Access Compliance Report

Public Rights-of-Way

(Curb Ramps)

Intersection ID: N/A	Main Street: CLANTON_RD	Cross Street: I-77_TO_CLANTON_RD	Location: NE
ADA ID: 1BE046BC7A97	Ramp Type: Perp	Initial Pass/Fail: Fail	Overall Compliance: No
			Severity Score: 13.75

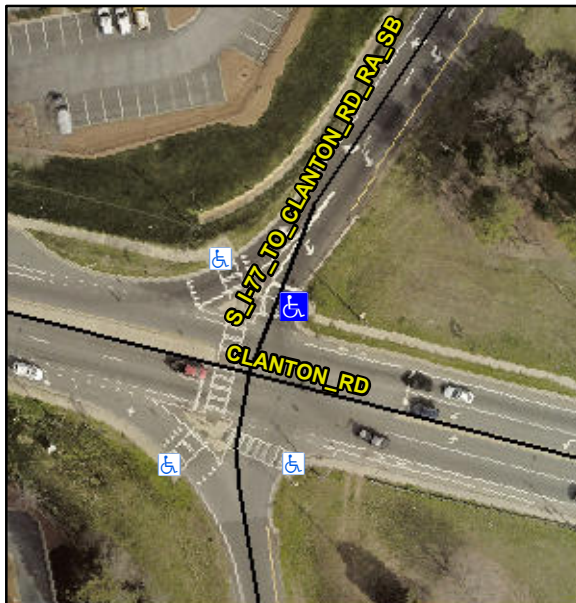
Not Found, R304.2.2, R304.5.3

Compliance	Description	Data	Compliance	Description	Data
N/A	Ramp Length (in)	120.0	No	Ramp Slope (%)	10.7
Yes	Ramp Width (in)	49.0	No	Ramp XSlope (%)	2.9
N/A	Flare Type LT	N/A	N/A	Flare Type RT	N/A
N/A	Flare Slope LT (%)	N/A	N/A	Flare Slope RT (%)	N/A
N/A	Flare Traversable LT?	N/A	N/A	Flare Traversable RT?	N/A
N/A	Landing Length (in)	N/A	N/A	DWS Provided?	N/A
N/A	Landing Width (in)	N/A	N/A	DWS Contrast?	N/A
N/A	Landing Slope (%)	N/A	N/A	DWS Length (in)	N/A
N/A	Landing X Slope (%)	N/A	N/A	DWS Full Width?	N/A
N/A	Landing Curb? (Y/N)	N/A	N/A	DWS Offset (in)	N/A
N/A	Shared Landing?	N/A			
N/A	Gutter Ponding?	N/A	N/A	Gutter Slope (%)	N/A
N/A	Gutter Lip Ht (in)	N/A	N/A	Gutter X Slope (%)	N/A
N/A	Painted X Walk1?	Yes	N/A	Painted X Walk2?	N/A
	X Walk 1 Direction	To W		X Walk 2 Direction	N/A
N/A	X Walk 1 Width (in)	109.0	N/A	X Walk 2 Width (in)	N/A
	X Walk 1 Slope (%)	2.5		X Walk 2 Slope (%)	N/A
	X Walk 1 X Slope (%)	0.5		X Walk 2 X Slope (%)	N/A

Remove & Replace Entire Ramp.
